RE: Application for Sign Permit
1101 W. University Dr. Rochester Hills, MI
HENRY FORD HEALTH

We are in receipt of your applications for multiple sign permits for the above-referenced location. However, some of your applications do not meet the requirements as set forth in our Ordinance for the following reason(s):

**HENRY
FORD
HEALTH**

E06
E06b

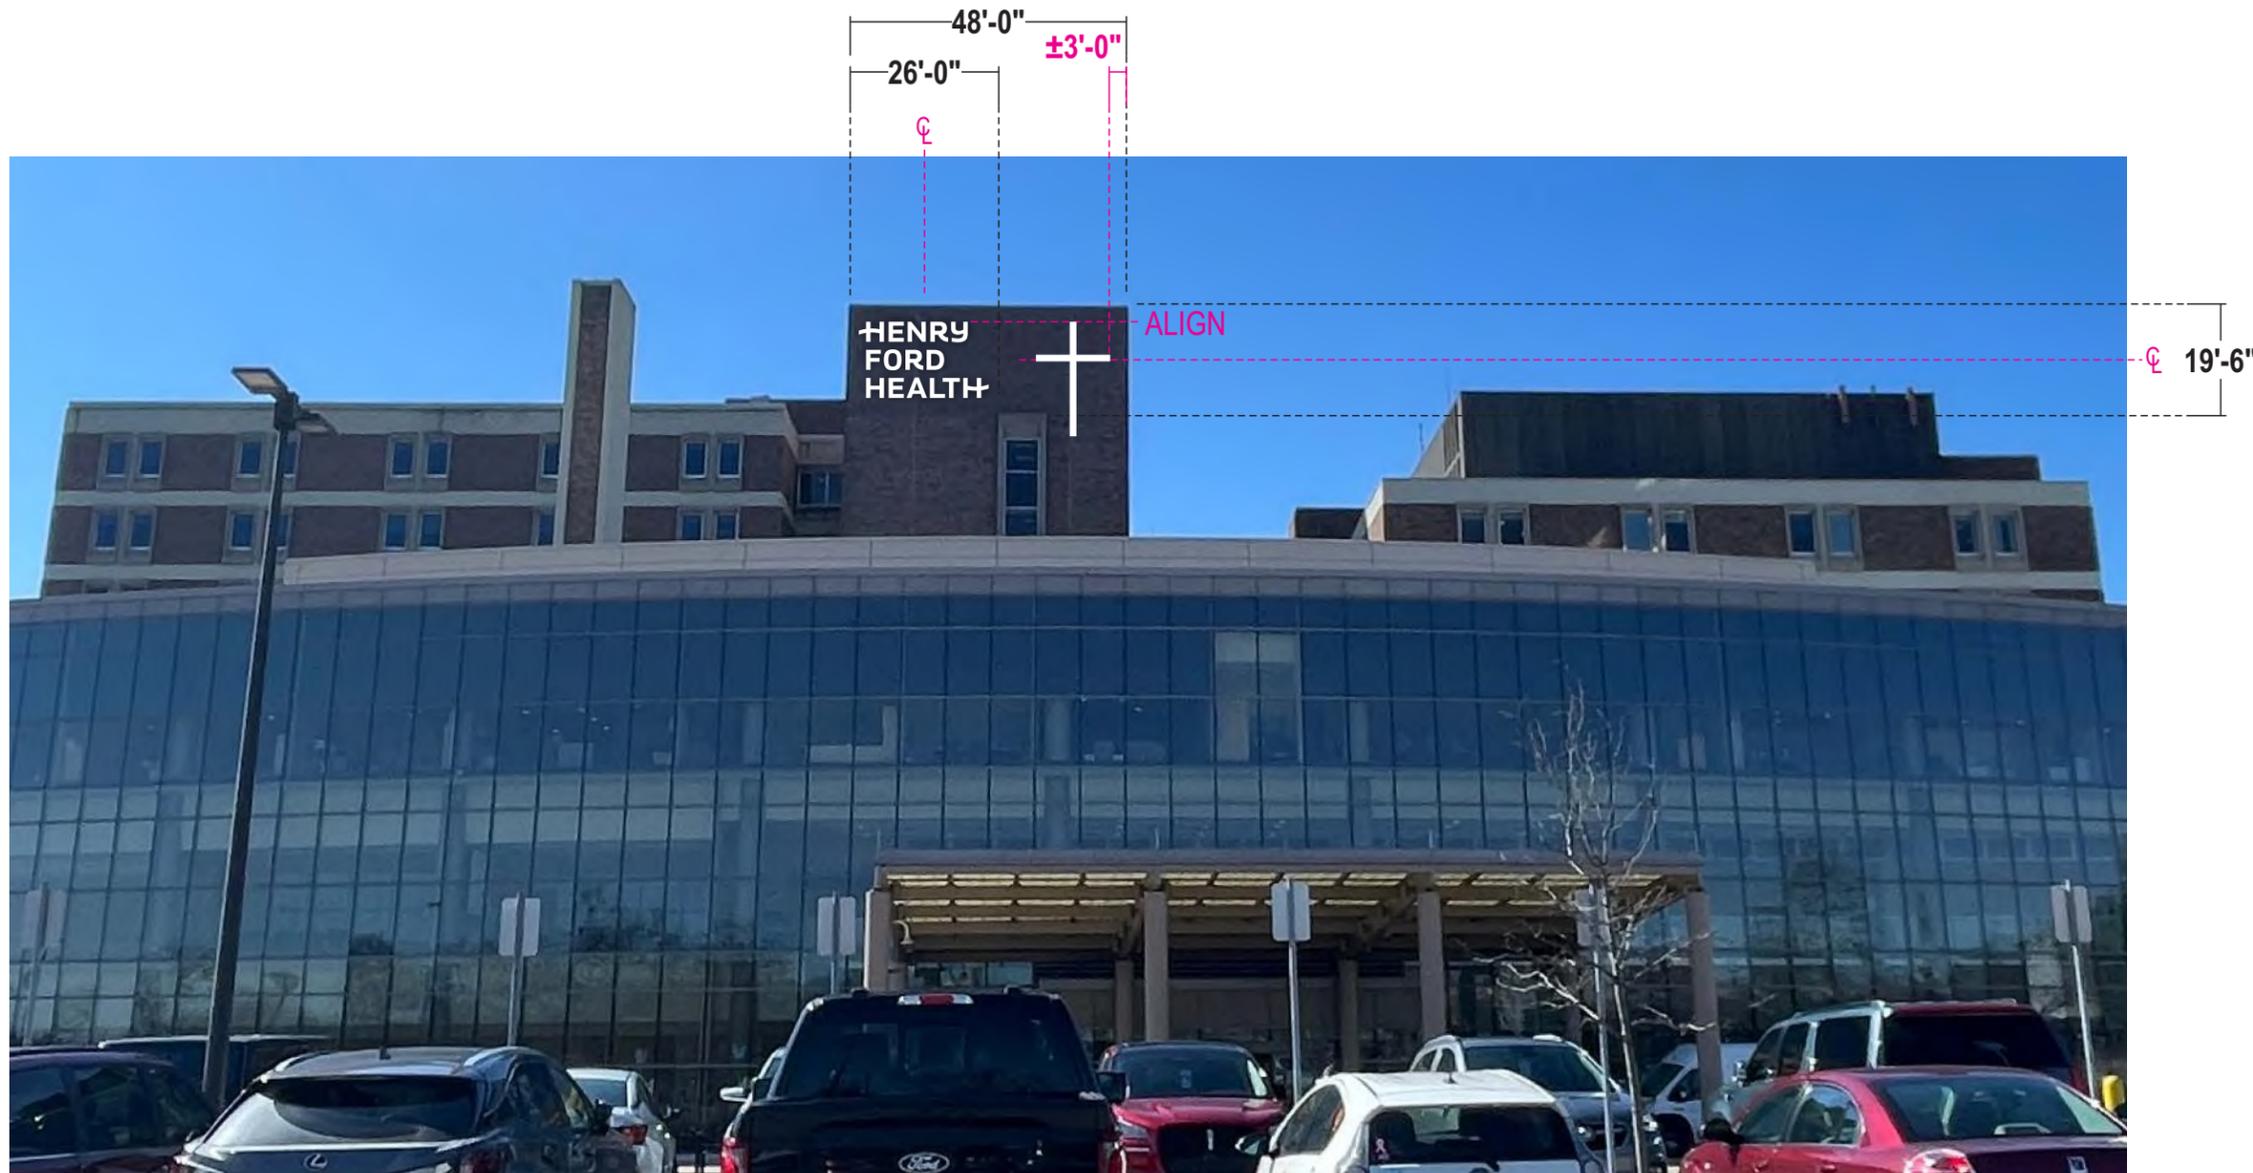
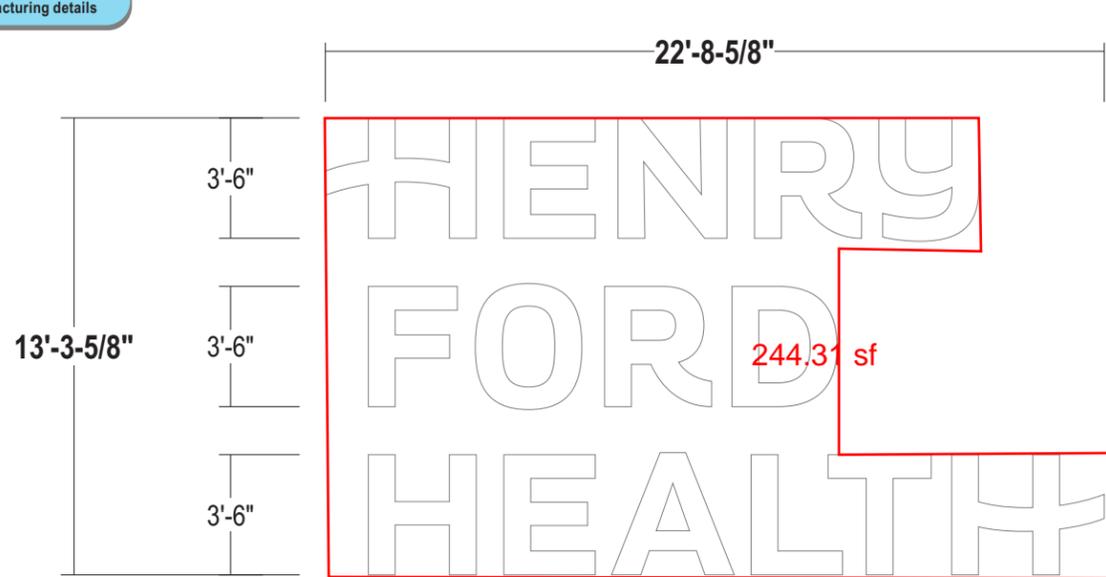
Sign E06 – Proposed wall sign is 244 square feet.

The proposed wall sign is in violation of the maximum size by 44 square feet.

E14 SITE PLAN & SETBACKS

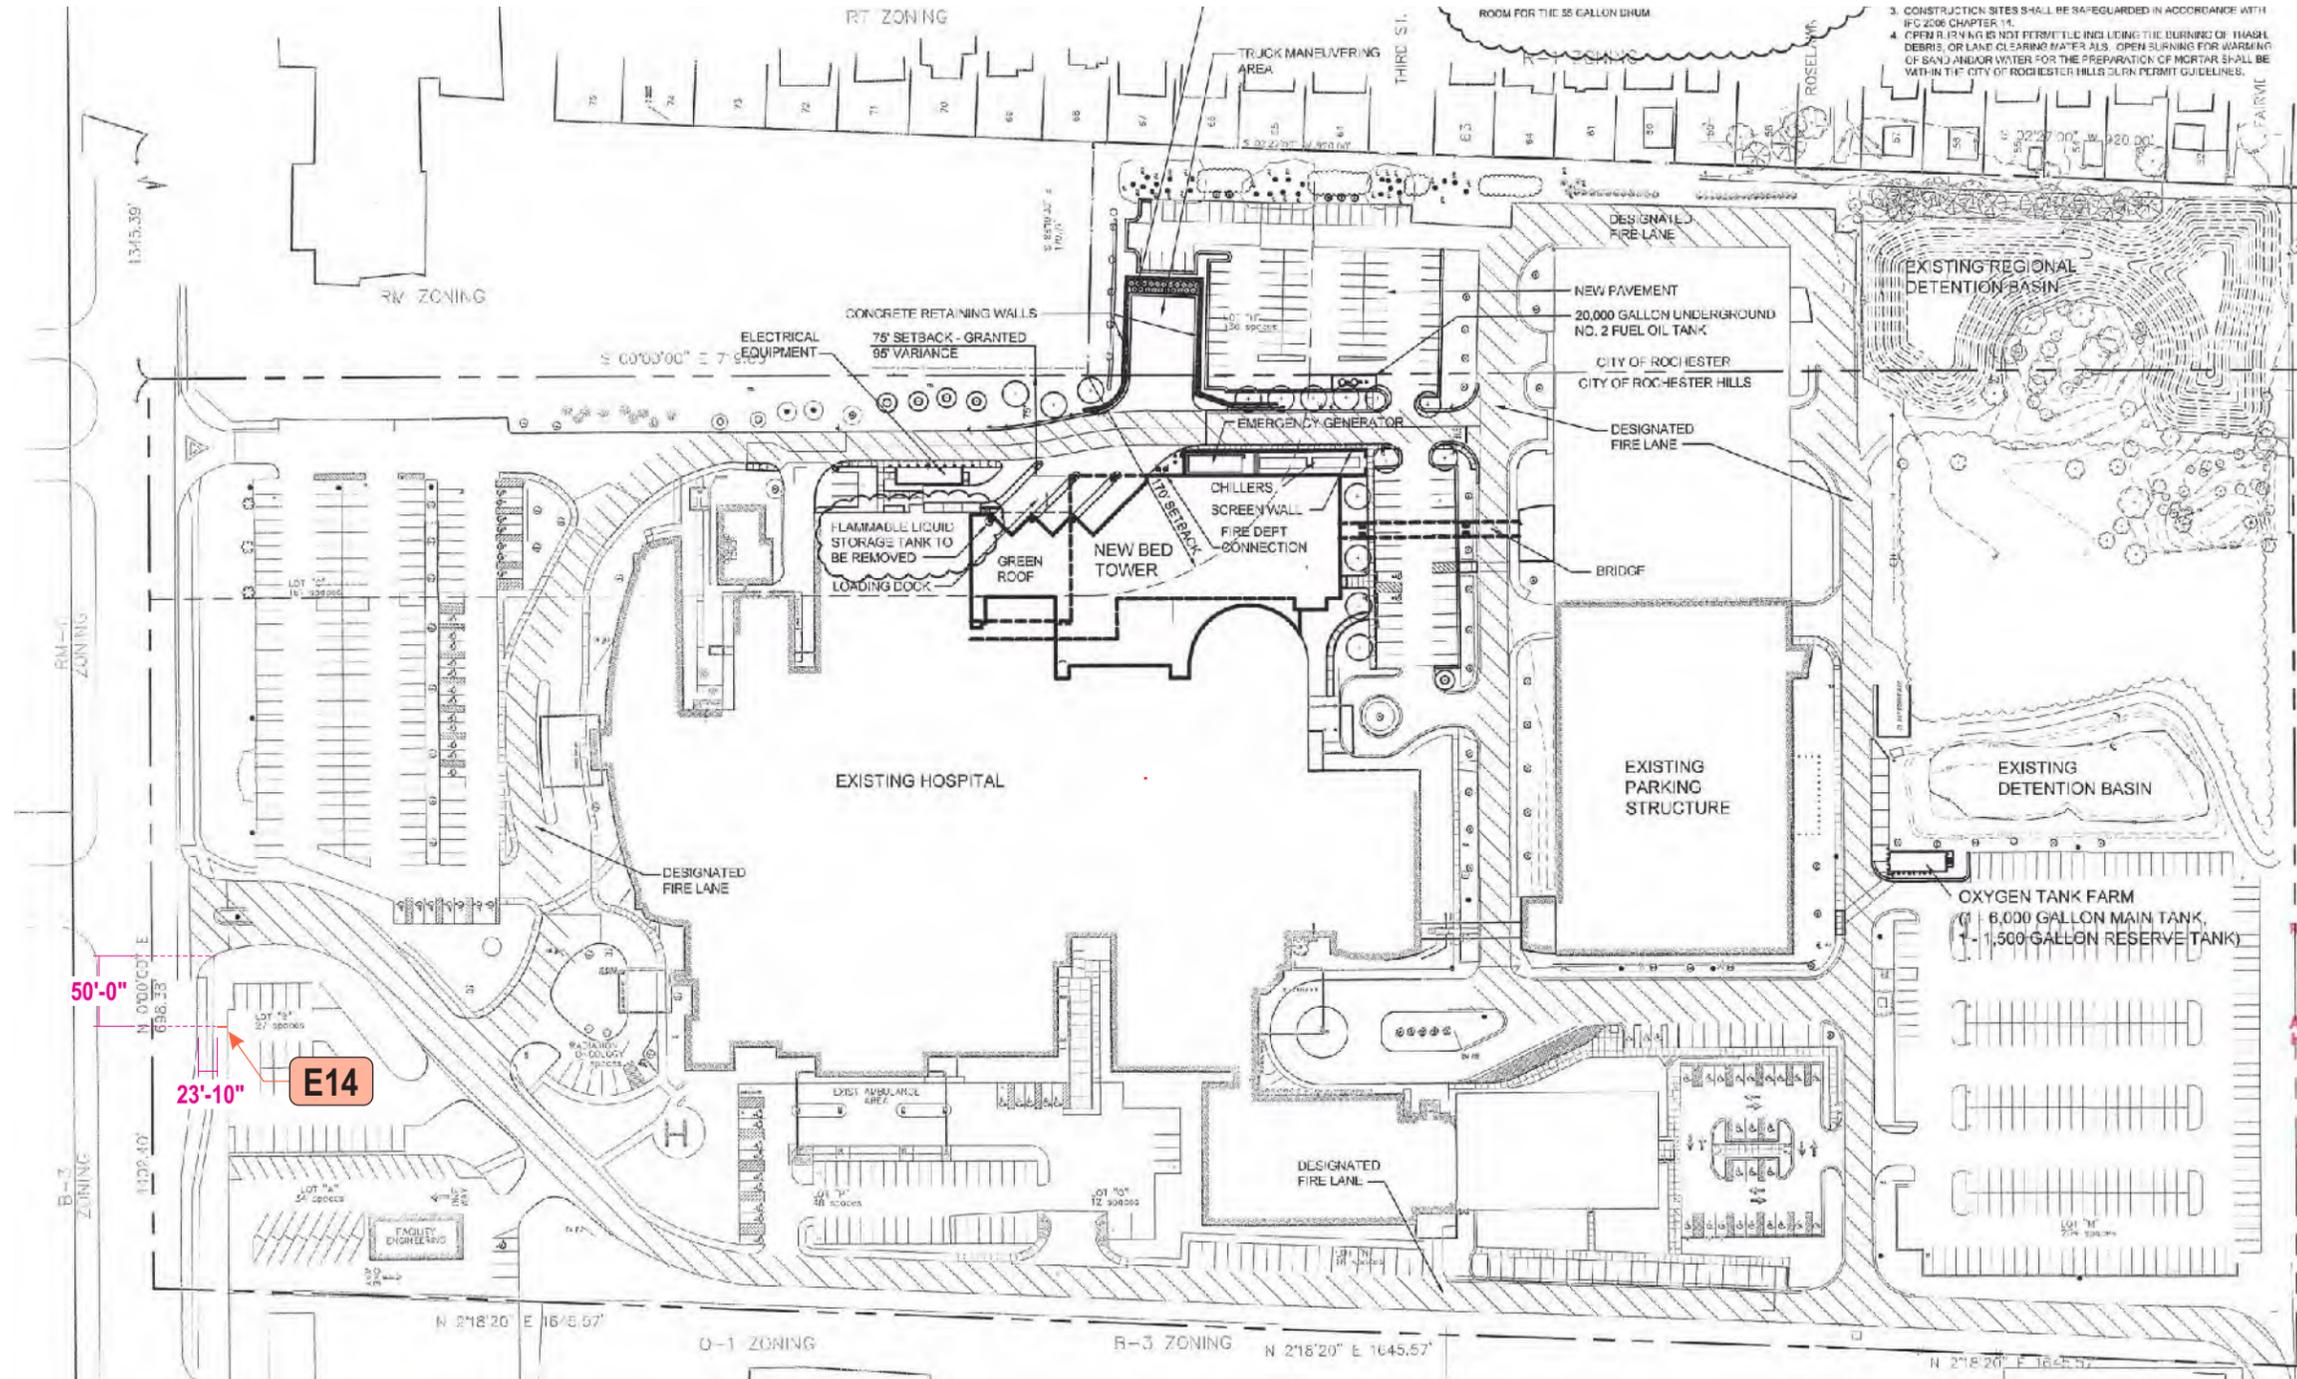
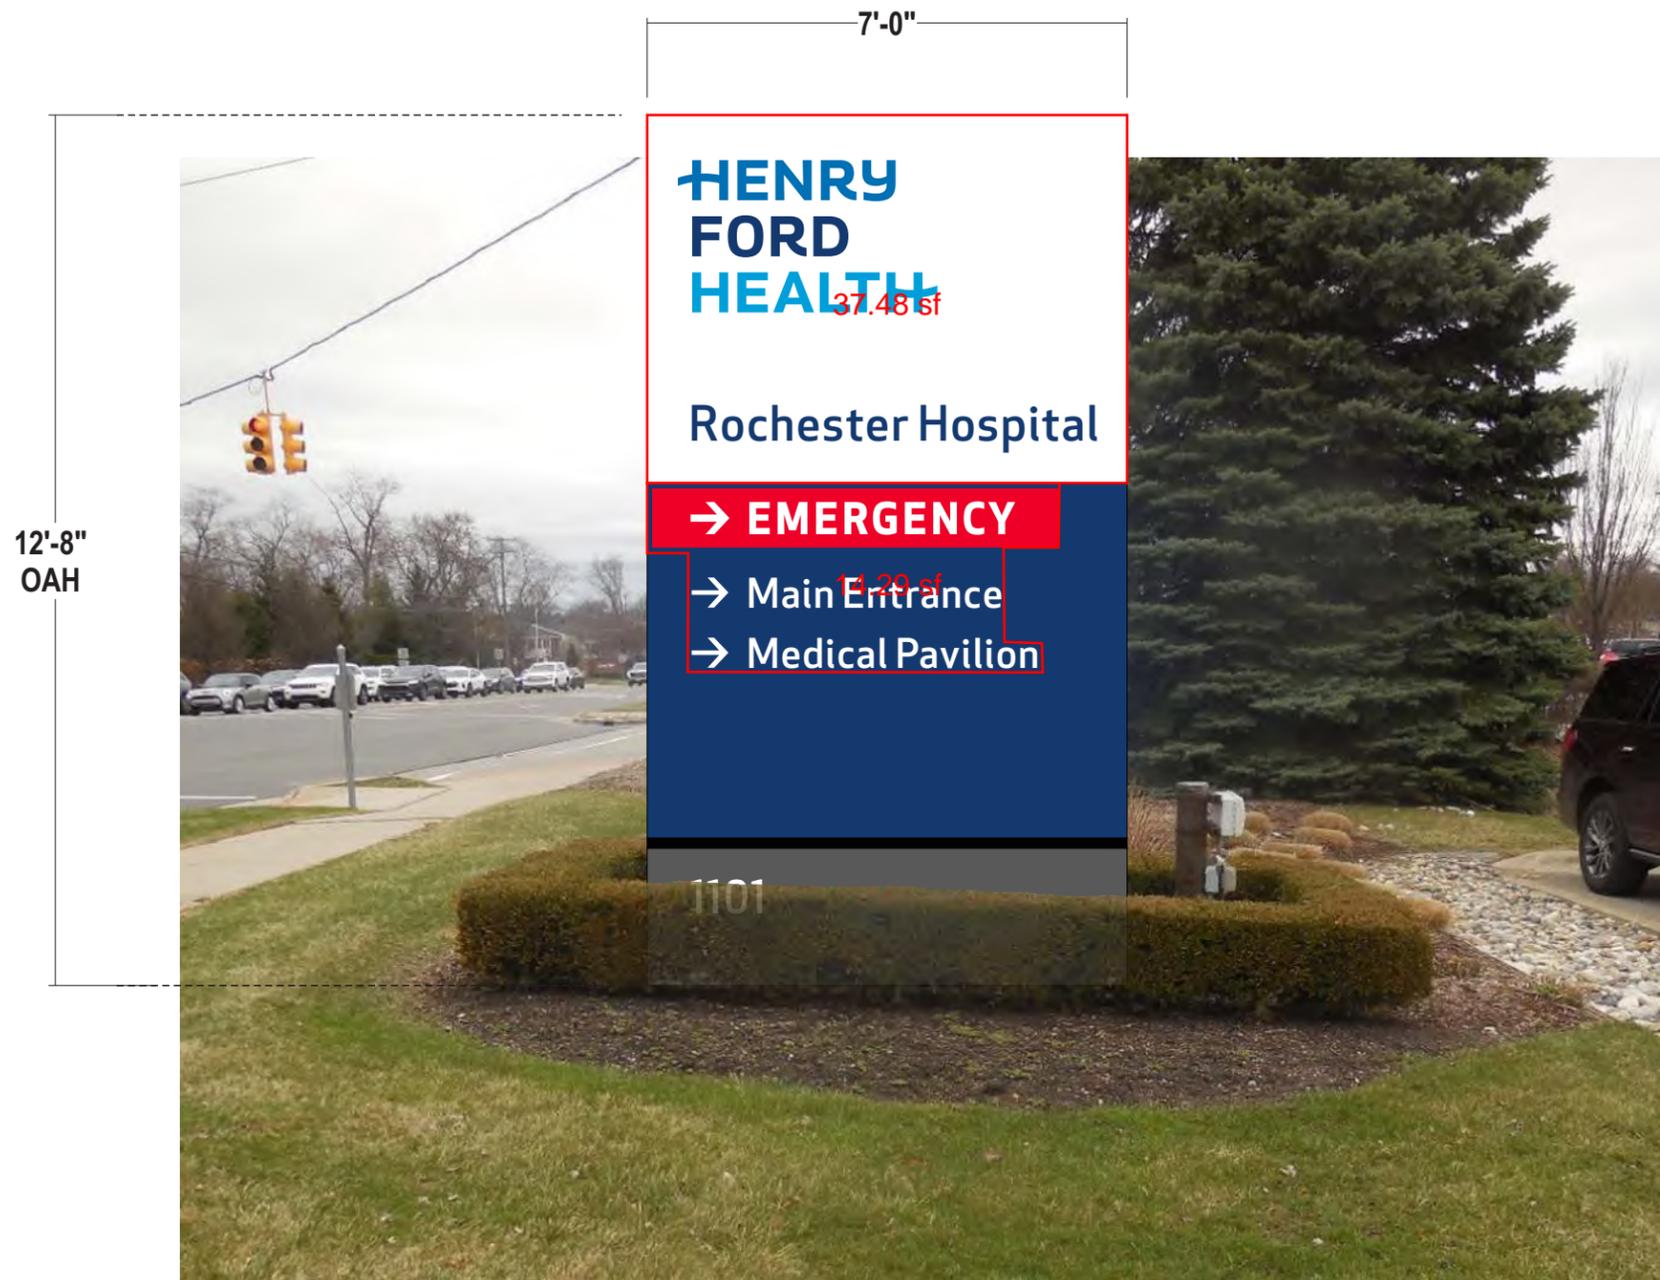
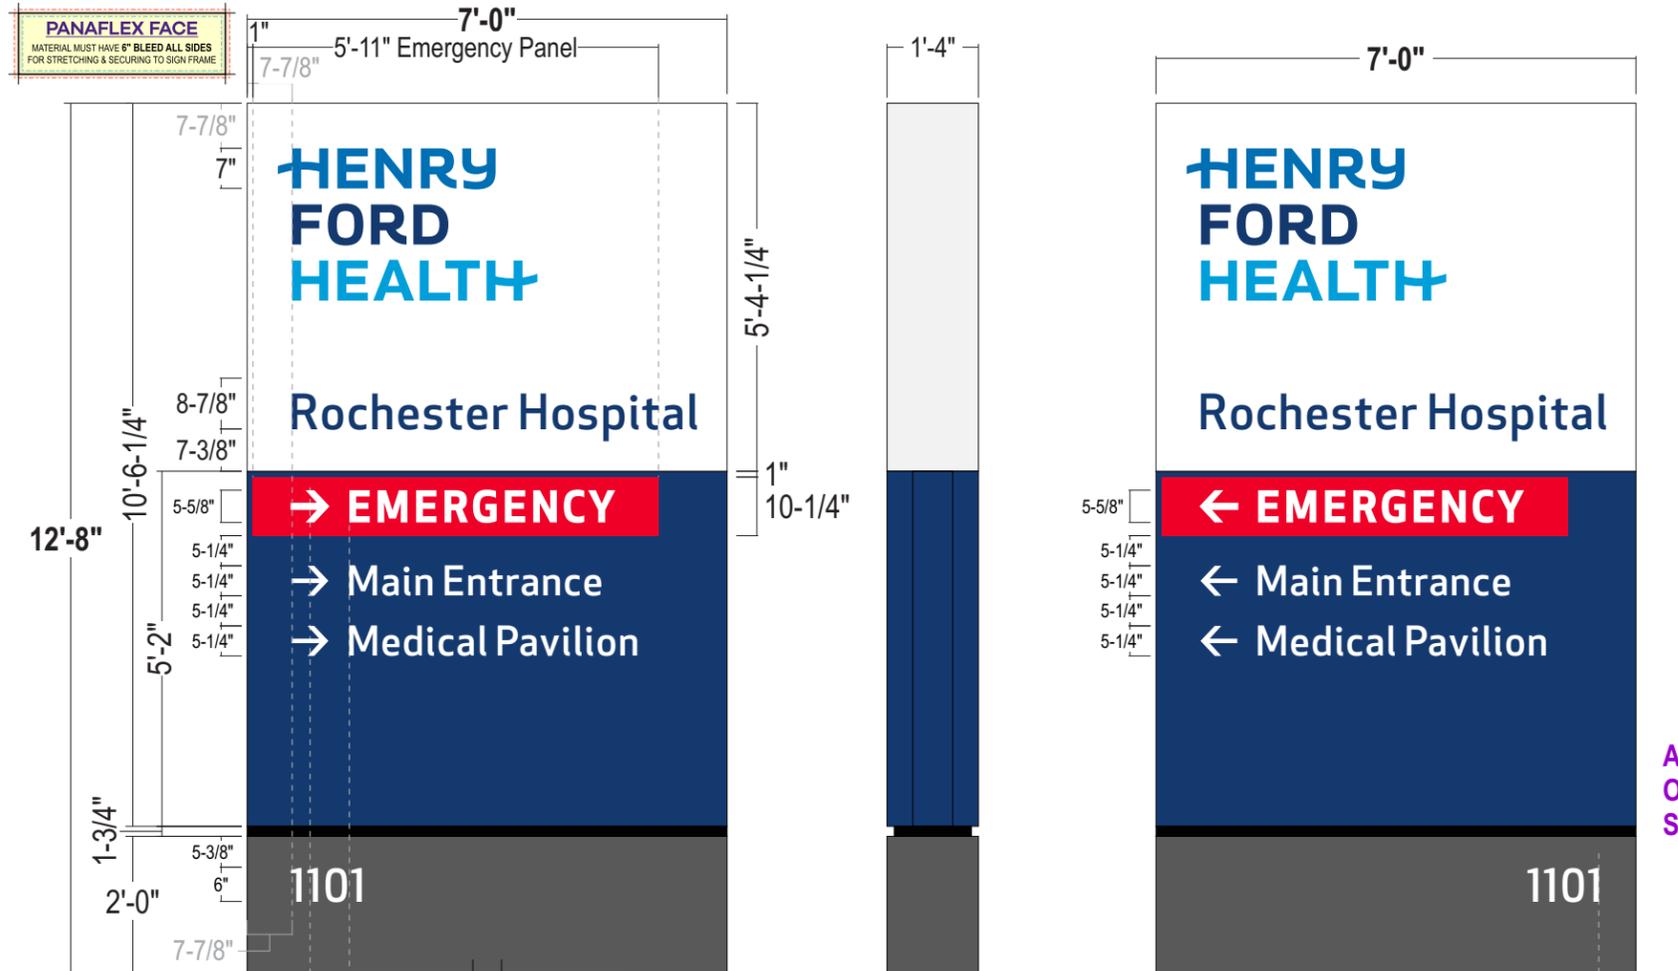
Sign E14 – Monument sign replacement with new footing. The proposed sign is 51.77 square feet (measured around the top illuminated panel and illuminated copy on bottom panel; address is not included), and a proposed height of 12.67 feet.

The proposed monument sign height of 12.67 feet for Sign E14 and Sign E43 are in violation of the maximum height by 5.67 feet.
